# STRAWBERRY HILL CENTER BUFFER REPLANTING

# STRAWBERRY HILL CENTER

## CHARLOTTE-MECKLENBURG PLANNING COMMISSION INTER-OFFICE COMMUNICATION

SUBJECT: Approved Landscape Plan for Petition No. 88-34 by Strawberry Hill Associates, Tax Parcel No. 185-121-29, 17

**PLANTING PLAN**

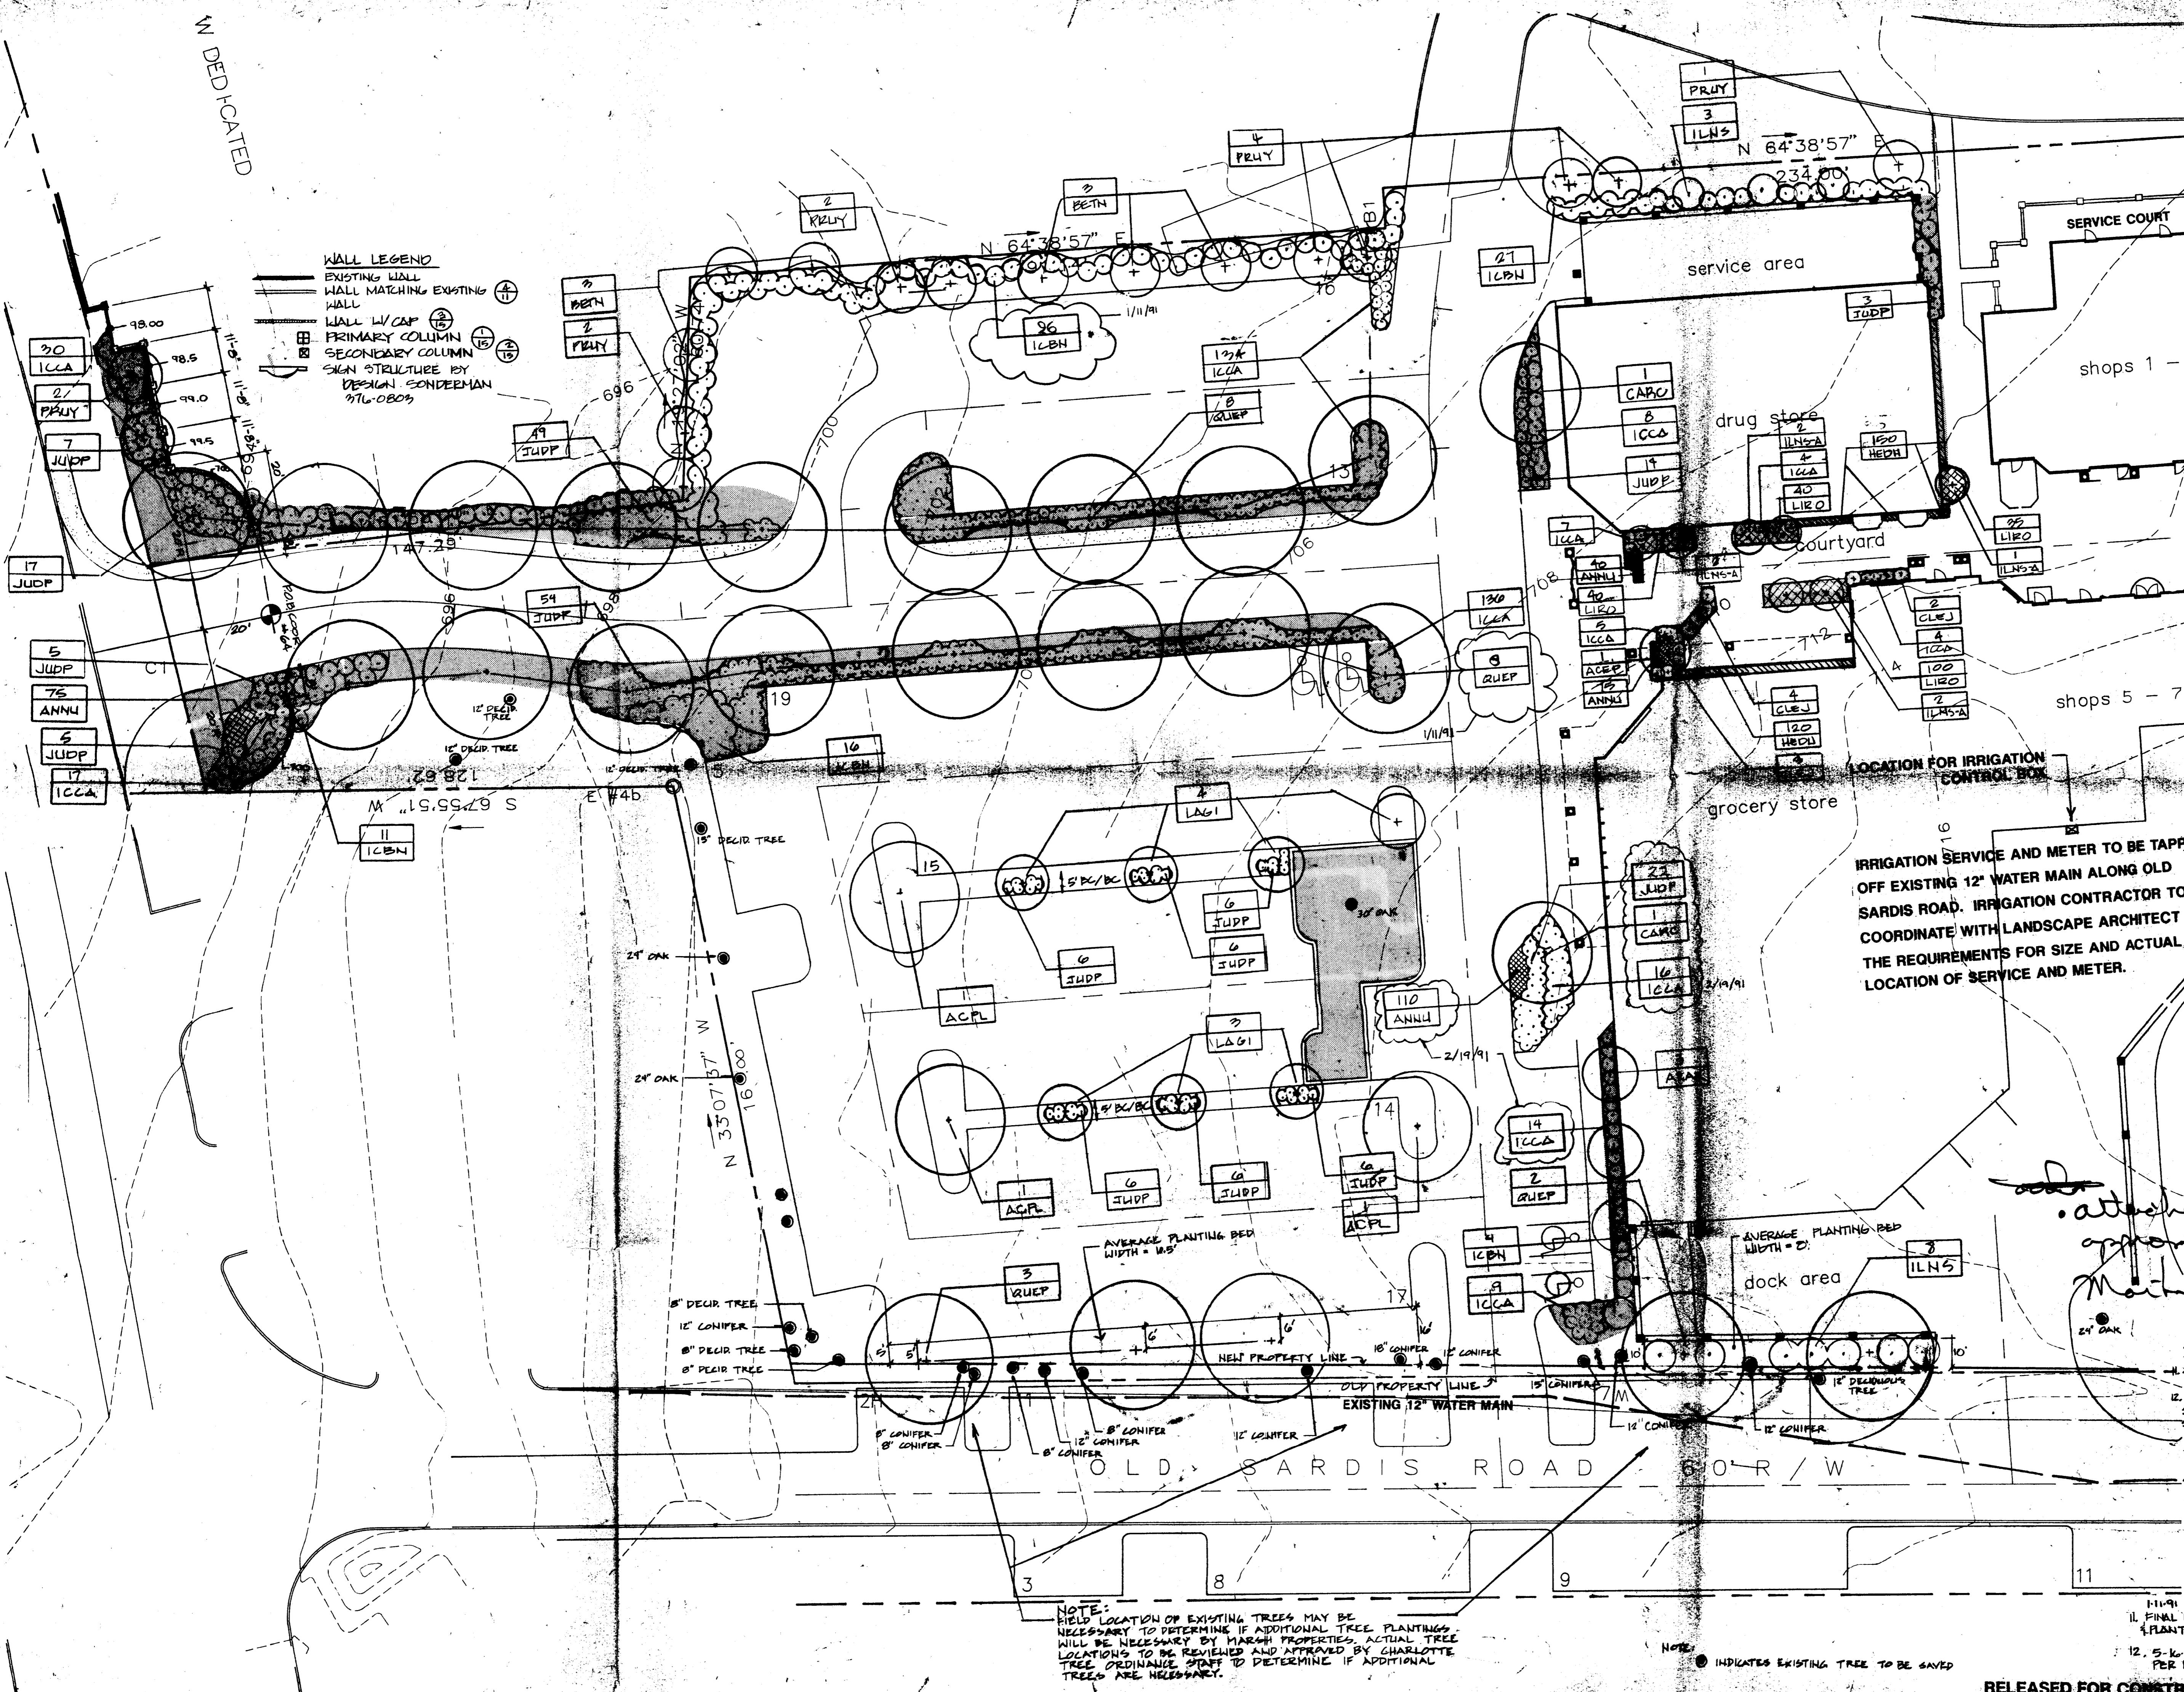
Attached is a revised landscape plan for the Strawberry Hill Shopping Center. The plan has been revised to add a service area behind shops 1-4. This service area will not be accessible by vehicles. The service area will be screened from the adjoining apartments by a brick wall and landscaping as shown on the attached plan. Pursuant to the authority granted to me by the zoning ordinance I am administratively approving this plan. Please use this plan when evaluating requests for building permits.

## PLANTING PLAN

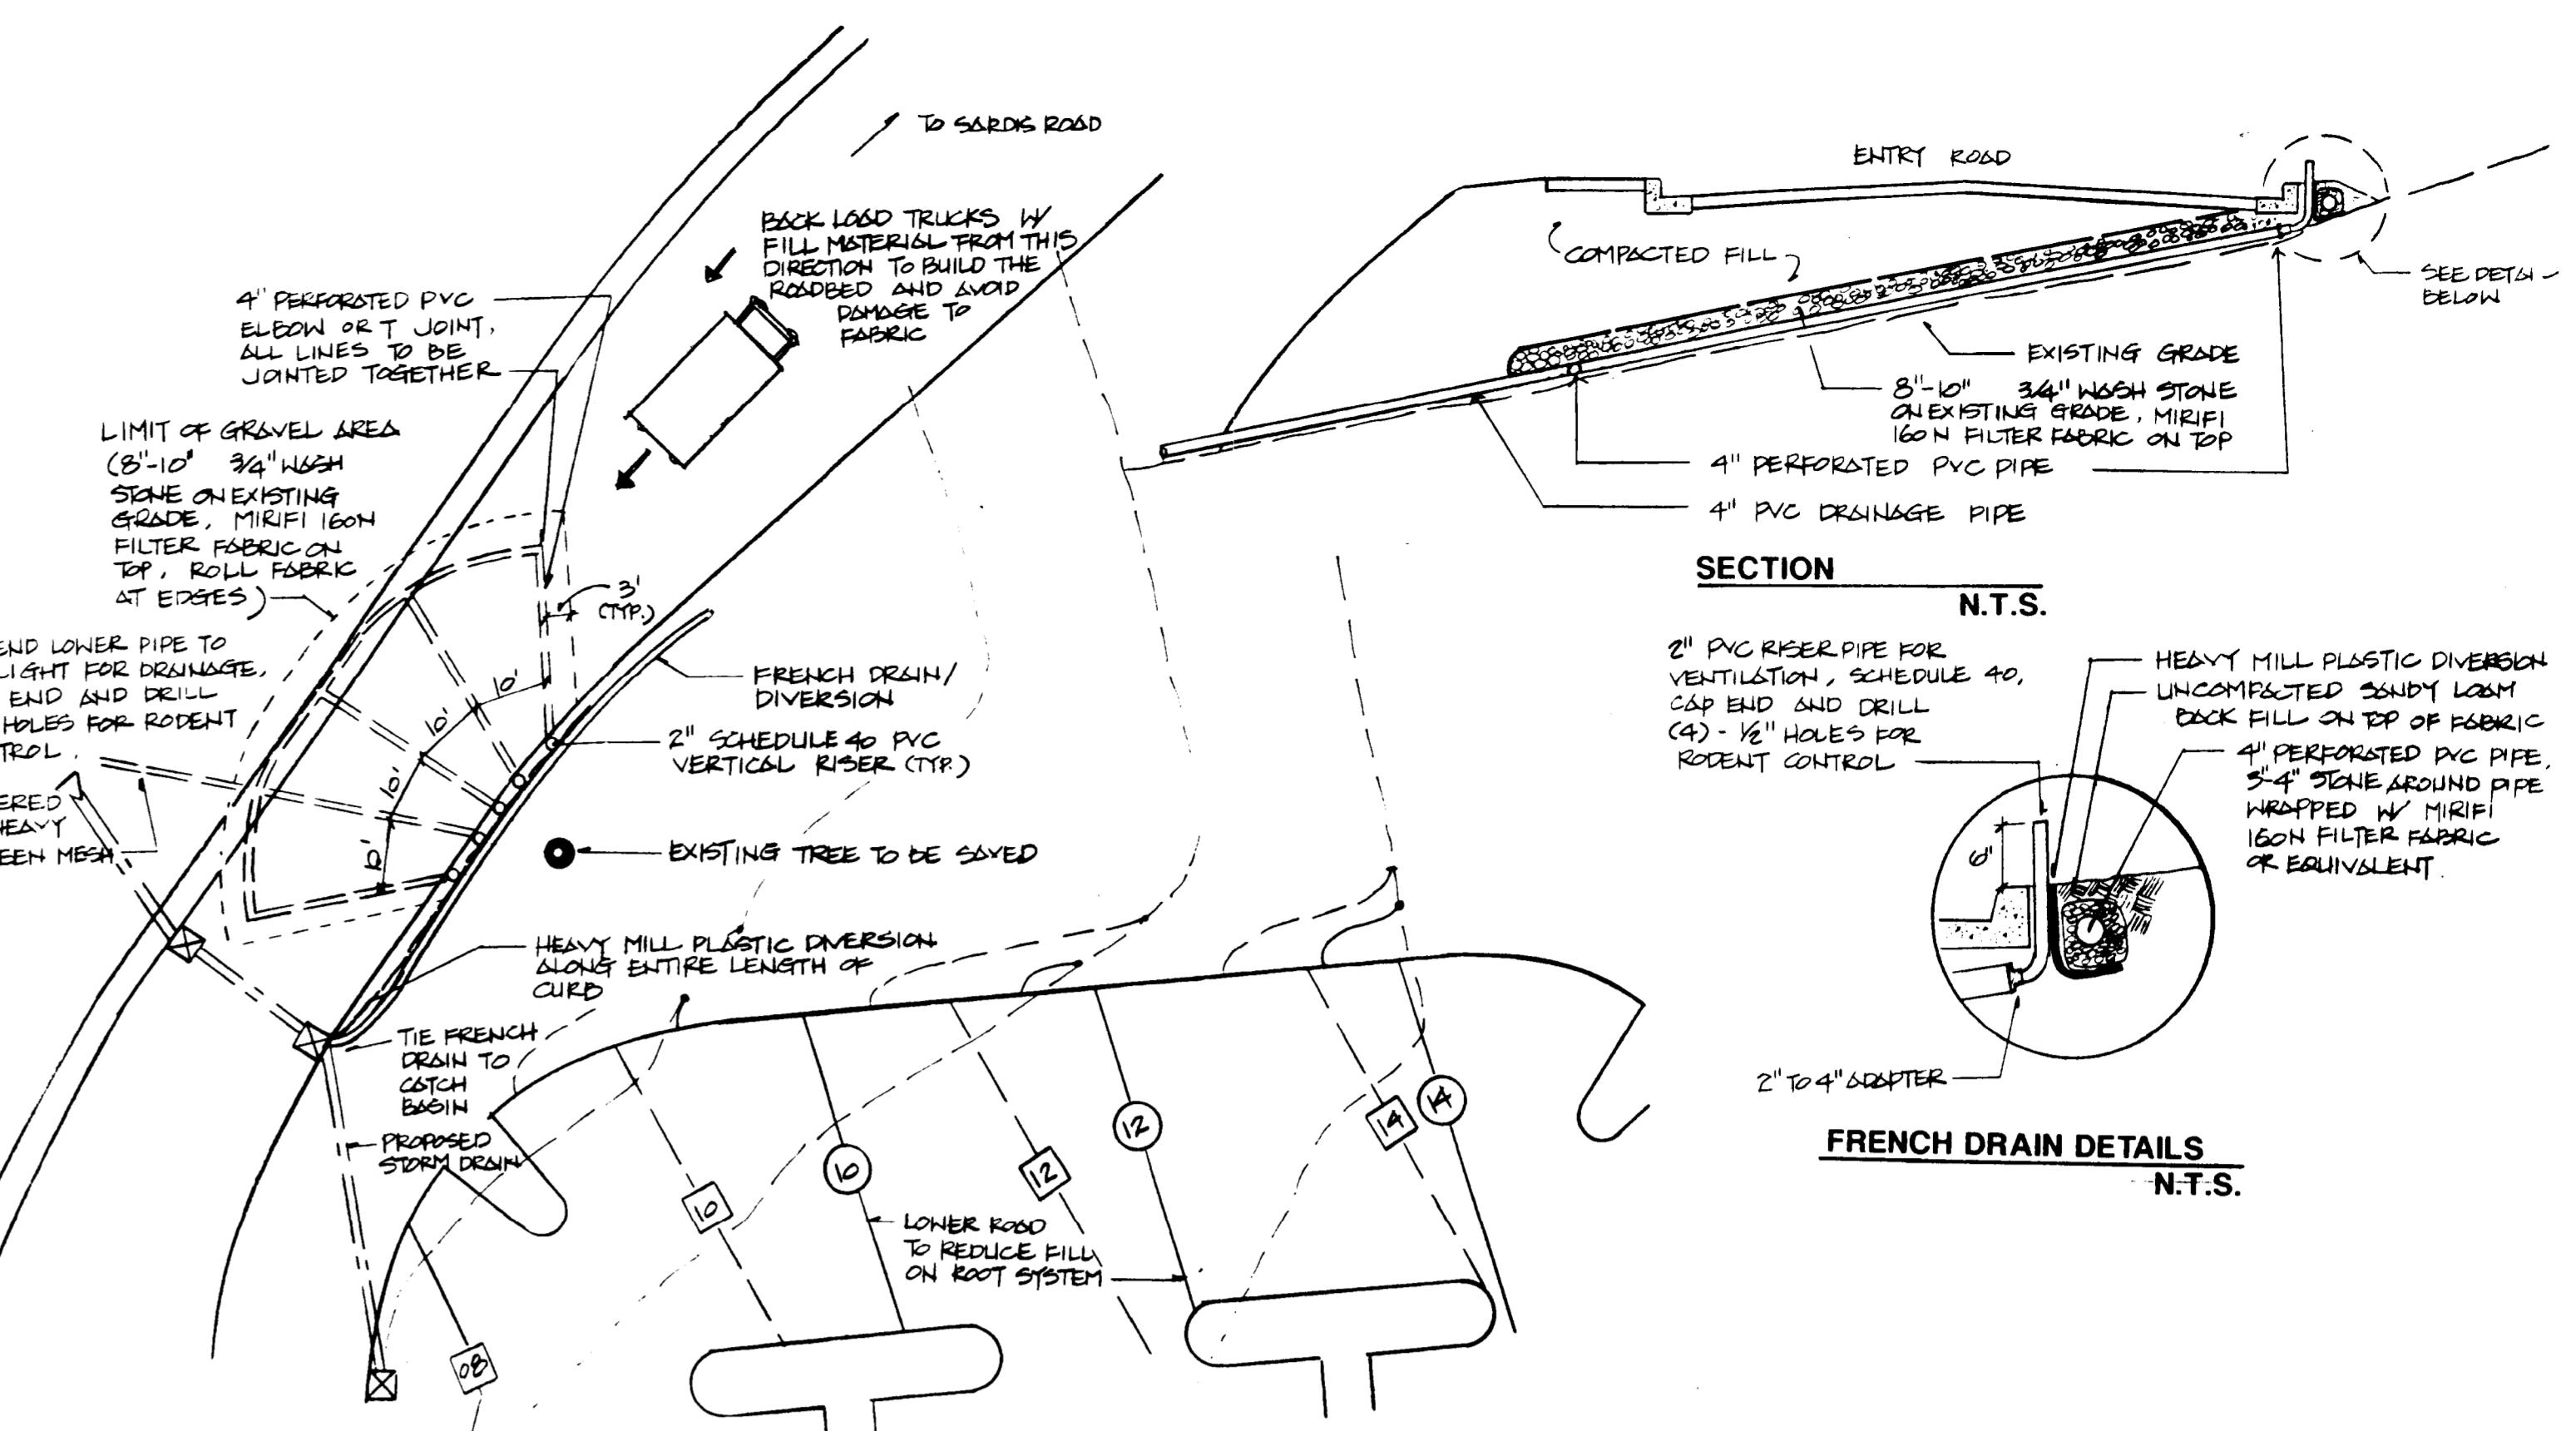
Attached is a revised landscape plan for the Strawberry Hill Center. The plan has been revised to show the final design and location of a break wall along Providence Road as well as along Sardis Road North. Pursuant to the authority granted to me by the zoning ordinance, I am administratively approving this plan. Please use this plan when evaluating requests for building permits and certificate of occupancy.
